10 December 2013
F500-L14-006

**Subject: Alternative Runway Configurations for the Nuevo Aeropuerto
Internacional de la Ciudad de México (NAICM)**

Alternative Runway Configurations for the Nuevo Aeropuerto Internacional de la Ciudad de México

**Prepared for
Aeropuertos y Servicios Auxiliares**

Figure 2. NAICM Alternative 1 Runway Configuration

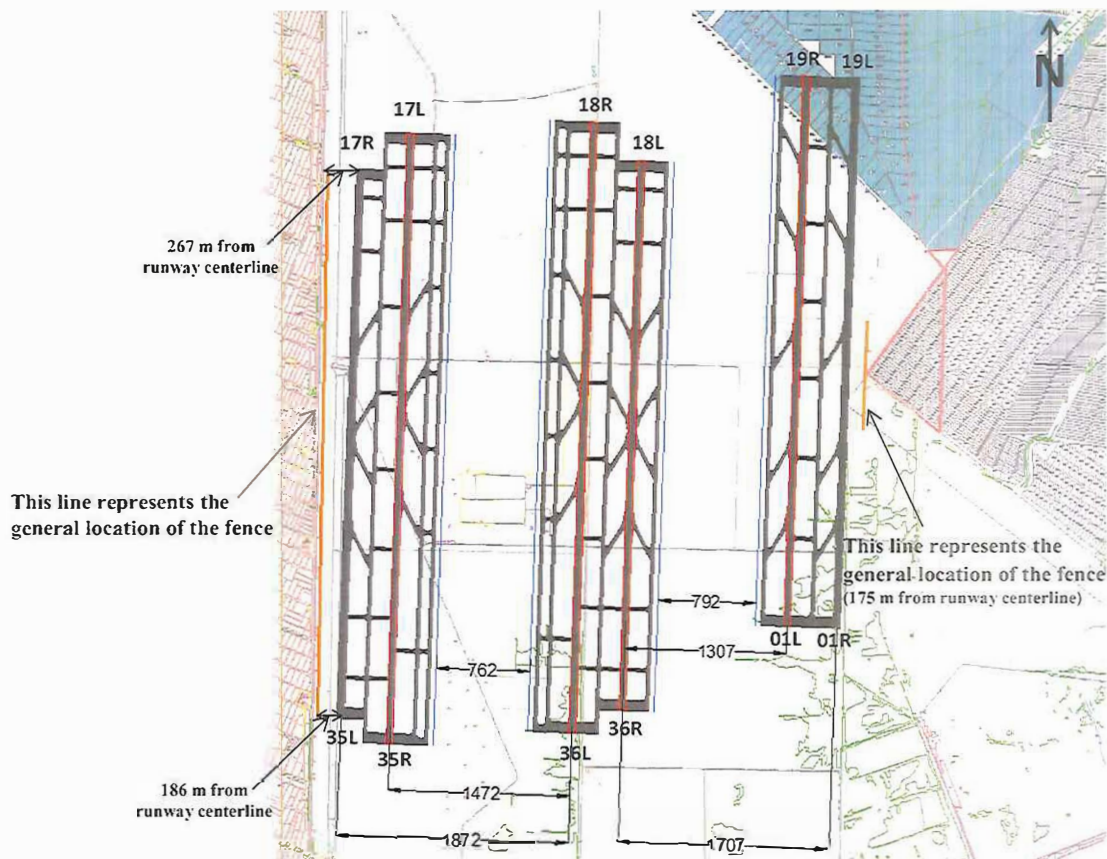
A major concern in the development of the *NAICM Alternative 1 Runway Configuration* is the amount of space between runways that could be used for terminal facilities. While the *MITRE-Recommended Runway Configuration (July 2012)* had a large area between the western and center pairs of runways, due to the minimum spacing required by aeronautical considerations for independent approaches being applied between Runways 35R and 36L (rather than between Runways 35L and 36L and Runways 35R and 36R), the available space for terminal facilities between these runways has been reduced in the *NAICM Alternative 1 Runway Configuration*. Note that at the time this runway configuration was developed, MITRE considered that ASA intended to locate the terminal building between Runways 35R and 36L. Therefore, MITRE considered dual parallel taxiways adjacent to those runways. Dual parallel taxiways were not considered between Runways 36R and 01L. As shown in Figure 2, there is 762 m of spacing available for terminal facilities between Runways 35R and 36L.

Figure 4. Comparison of the NAICM Alternative 2 Runway Configuration, Shown in Black, to the MITRE-Recommended Runway Configuration (July 2012), Shown in Red

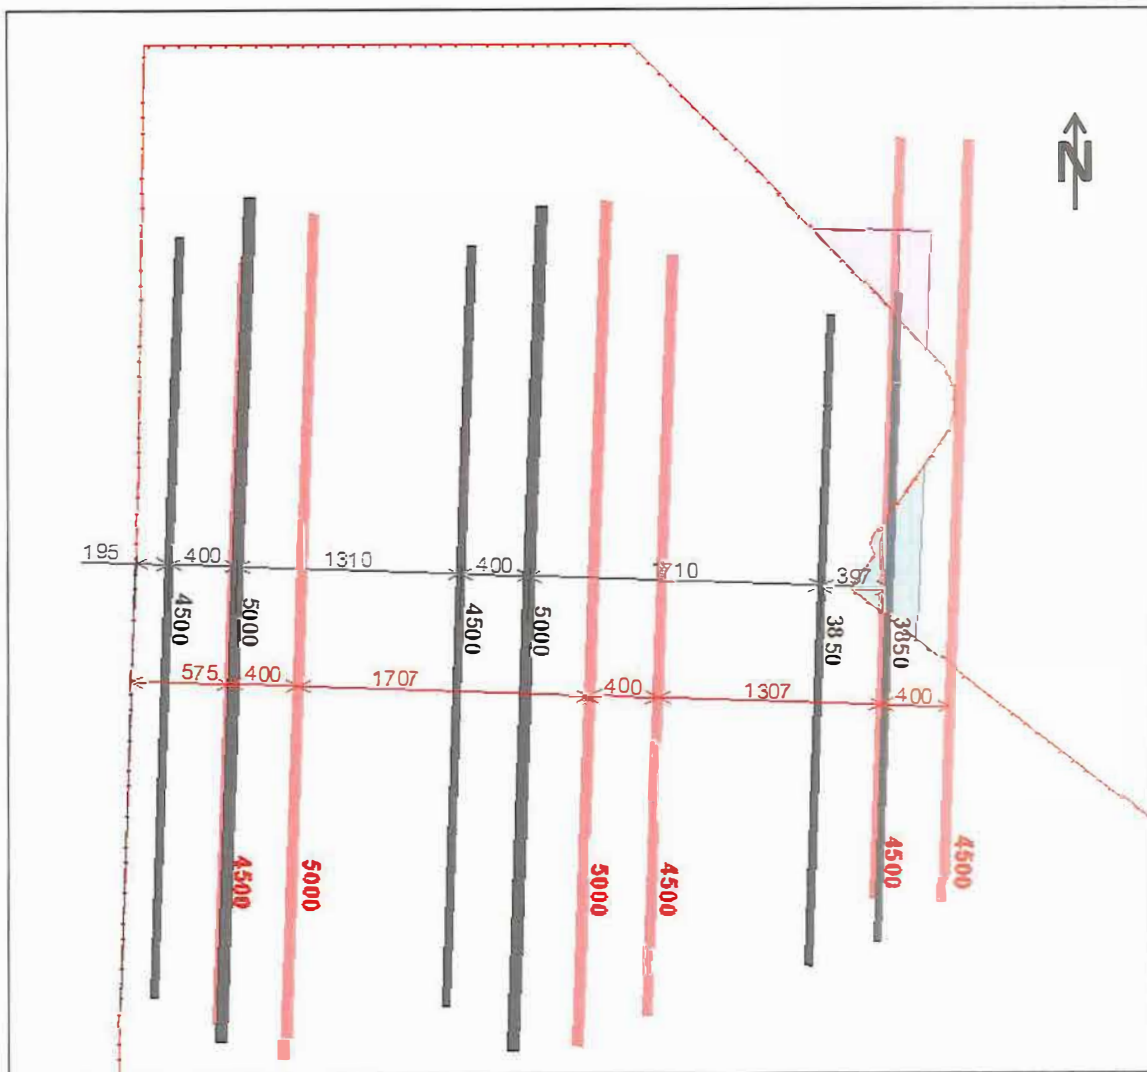
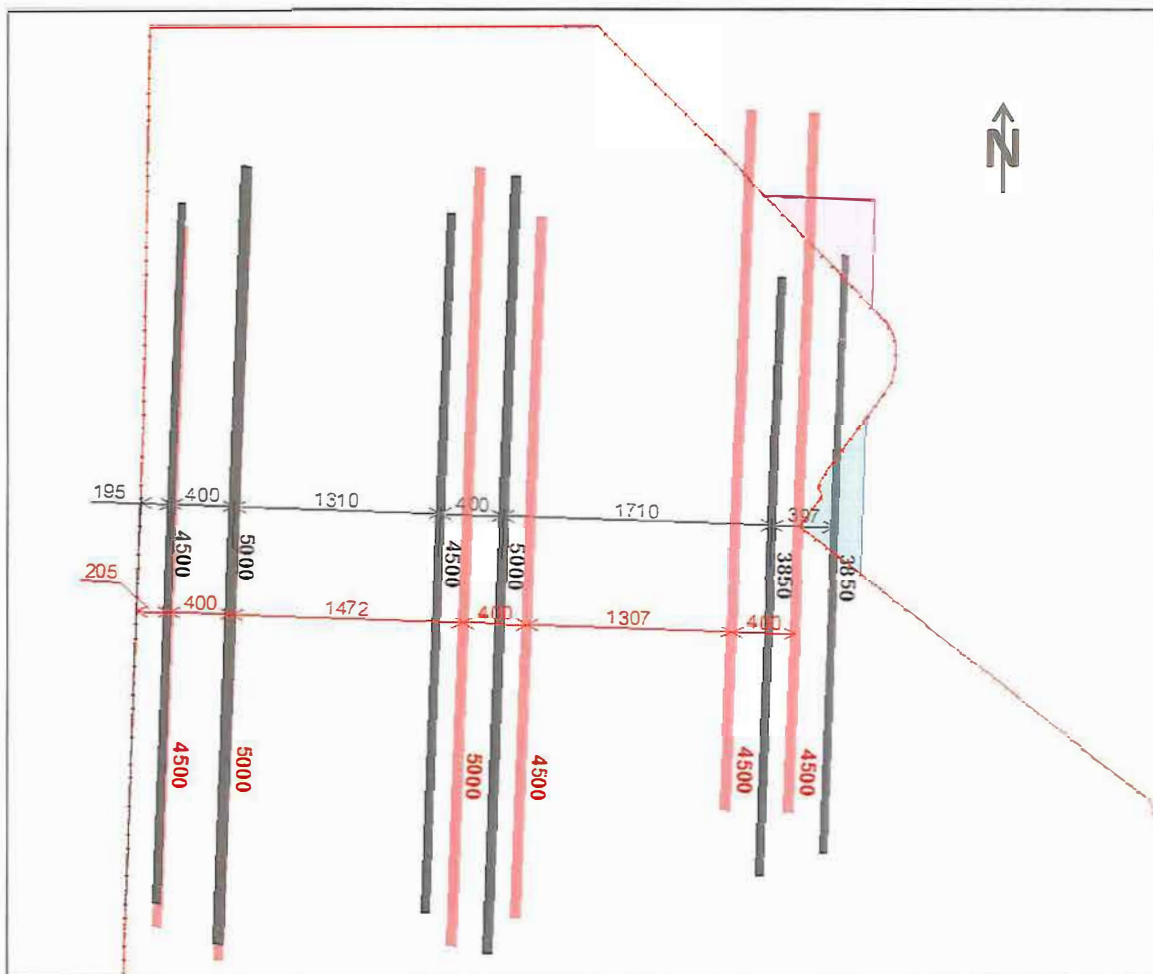
On 26 November 2013, MITRE received from ASA an AutoCAD drawing and graphic depicting a runway configuration for NAICM different than those proposed by MITRE earlier. This configuration, referred to in this document as the *NAICM Alternative 2 Runway Configuration*, is shown in Figure 3. A graphical comparison of the *NAICM Alternative 2 Runway Configuration* to the *MITRE-Recommended Runway Configuration (July 2012)* is shown in Figure 4. Also, a graphical comparison of the *NAICM Alternative 2 Runway Configuration* to the *NAICM Alternative 1 Runway Configuration* is shown in Figure 5.

The eastern runway pair (Runways 5 and 6) are only 3850 m in length. This is a significant reduction from the 4500 m runways being proposed in MITRE's configurations. Although this length is just slightly shorter than the runways at the existing Benito Juárez International Airport in Mexico City, it is likely that in the future there may be a significant number of aircraft that would require one of the other longer runways, especially for takeoff. Although there are two 5000 m runways in the design, the need to assign a significant number of aircraft departing to or even arriving from the eastern periphery of the terminal area will complicate the airspace design, as described below.

The width of the runways was measured in the ASA-provided AutoCAD drawing. The two 5000 m runways have a width of 60 m. However, the other four runways have a width of only 45 m. MITRE recommends that all runways have a width of 60 m.

It appears from the drawing and runway lengths that the nominal runway-use strategy would be to operate arrivals on Runways 1, 3, and 5 and departures on Runways 2, 4, and 5. Runway 5 would operate in mixed mode, which would reduce overall capacity. When Runway 6 is constructed, not a clear development from the information received by MITRE, arrivals would then shift to that runway, leaving Runway 5 as a departure runway.

- If Runway 1 is closed, then its arrivals are moved to Runway 2, which operates in mixed mode. Runways 3 and 4 are switched, with arrivals on Runway 4 (to give 1710 m separation from arrivals on Runway 2) and departures on Runway 3 (departures that require the full 5000 m runway length would be assigned to Runway 2). There will still be 1710 m separation between arrivals on Runways 4 and 5.
- If Runway 2 is closed, departures from that runway are shifted to Runway 1, which operates in mixed mode. Departures requiring the full 5000 m runway length would be assigned to Runway 4.

- If Runway 3 is closed, those arrivals are shifted to Runway 4 (operating in mixed mode) and there is still a 1710 m separation between arrivals on Runways 4 and 5.
- If Runway 4 is closed, departures from that runway are shifted to Runway 3, which operates in mixed mode. Departures requiring the full 5000 m runway length would be assigned to Runway 2.
- If Runway 6 is built, then either Runway 5 or 6 can be closed, with the other runway serving both arrivals and departures in mixed mode. There will be sufficient separation to have triple independent parallel approaches.
 - Clearly, if Runway 6 is not constructed and Runway 5 is closed, the airport will be reduced to operating two arrival streams and two departure streams, which would result in a significant reduction of runway capacity.

The operational flexibility of the *NAICM Alternative 2 Runway Configuration* is therefore equivalent to that of the *NAICM Alternative 1 Runway Configuration*, but clearly less flexible than the MITRE-Recommended Runway Configuration (July 2012).

The design of the *NAICM Alternative 2 Runway Configuration* appears to plan for the east midfield terminal to be the main passenger facility (with an east-west dimension of 1020 m); the smaller west midfield terminal (with an east-west dimension of 620 m) would serve a supporting role. MITRE had always planned on locating the main terminal between the western and center pairs of runways.

Additional information provided to MITRE by ASA after 26 November 2013 indicates that the rationale for locating the main terminal between the center and eastern pairs of runways is due to soil drainage issues on the western part of the site. However, the MITRE team feels that, regardless of where the main terminal is built, these issues need to be resolved in order to construct the western pair of runways and other airport related facilities and components. Otherwise, triple approach capacity will not take place and overall capacity will lead to an airport saturated relatively soon. Furthermore, MITRE recommends that the most extreme runways, i.e., Runways 1 and 6 be constructed first, in order to “stake claim” on that land.

Note that if the terminal building were to be constructed in the area to the east of the center pair of runways and Runway 6 were never built, then the operation of the airport would be significantly less efficient compared to if the main terminal were placed to the west of the center pair (the most efficient operation is when the terminal is located between the main runways or runway pairs). Moreover, aircraft requiring the longer 5000 m runway (i.e., Runway 2) would need to taxi a much longer distance.

The design of the *NAICM Alternative 2 Runway Configuration* appears to provide sufficient distance from boundaries and other nearby infrastructure, such as the major drain (*dren*). There are at least 3 km from all runway ends to Lago Nabor Carrillo.

It is worthwhile mentioning that ASA reported to MITRE an intention by the Comisión Federal de Electricidad (CFE) of installing a power line in the proximity of the NAICM site. Preliminary information indicates that the proposed power line would be very close to the *NAICM Alternative 2 Runway Configuration* (as well as the *NAICM Alternative 1 Runway Configuration*).

The design of the *NAICM Alternative 2 Runway Configuration* provides only 190 m of separation between the parallel taxiway and Runways 2 and 3 and Runways 4 and 5 (on the side of those runways adjacent to the terminal buildings). MITRE recommends, however, 200 m of separation between runways and parallel taxiways. This may not be a significant issue, however, as the dual parallel taxiways utilized in the design may provide more flexibility for aircraft maneuvering. Nevertheless, MITRE recommends that the maneuvering of very large aircraft (such as the Airbus A380) be further evaluated.

As mentioned above, the relatively short 3850 m length of the eastern runway or runway pair could result in a significant proportion of aircraft requiring one of the other runways (particularly for takeoff), depending on how NAICM and its fleet mix evolve in the future. This will increase the need to vector traffic within the terminal area such that an aircraft that is using one of the longer runways can exit the terminal area in the east. The conceptual airspace design developed by MITRE for use with NAICM would need to be modified for this purpose, and this need to vector aircraft around the terminal area may add to the complexity of operations and controller workload.

Figure 6. NAICM Alternative 3 Runway Configuration

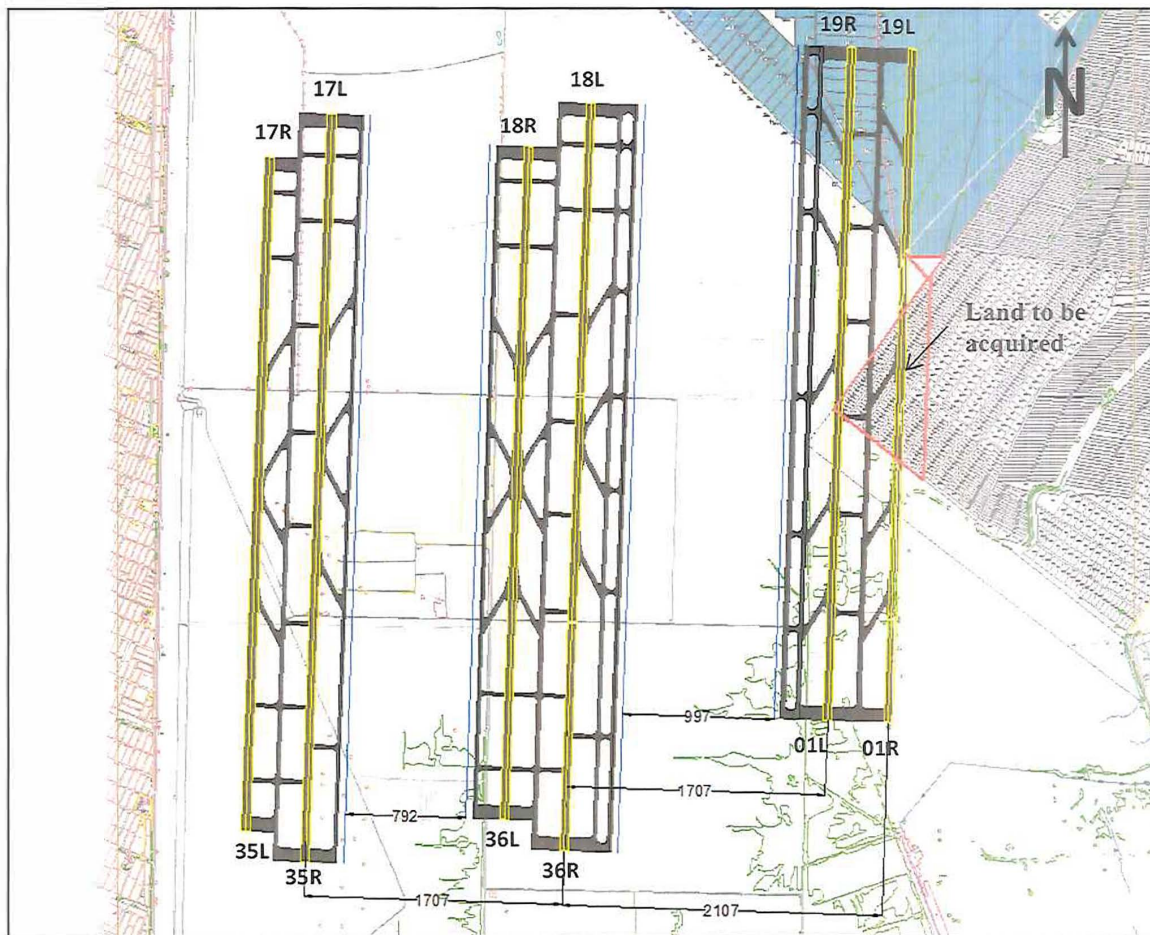
As previously mentioned, MITRE has always planned on locating the main terminal between the western and center pairs of runways. However, if there were some advantage of locating the main terminal facility between the center and eastern runway pairs, one alternative could be to modify the *MITRE-Recommended Runway Configuration (2012)* described in Section 2 by shifting the center pair of runways to the west. The advantage of this approach is that aeronautical feasibility would only need to be reestablished for the center pair of runways, as the other four runways are at locations previously analyzed. Moreover, since the center runway pair would be shifted 400 m to the west and the arrival and departure assignments of this pair are being switched (i.e., Runway 3 would be used for departures and would be 5000 m in length, while Runway 4 would service arrivals and would be 4500 m in length), the new Runway 4 would be located in exactly the same position as the original Runway 3. Therefore, only the new Runway 3 would need to be aeronautically re-evaluated. Note also that noise impact would need to be re-examined. A conceptual depiction of this runway

configuration, referred to as the *NAICM Alternative 3 Runway Configuration*, is shown in Figure 6. Runway lengths are unchanged from those given in Table 1, except that the lengths of Runways 36L/18R and 36R/18L are reversed.

It is important to reiterate, however, that a relatively small non-federal area to the north and east must still be acquired in order to construct the easternmost pair of runways. Also, if the terminal building were constructed in the area to the east of the center pair of runways, it is critical that enough land be obtained to build both of the easternmost pair of runways to ensure an efficient operation.
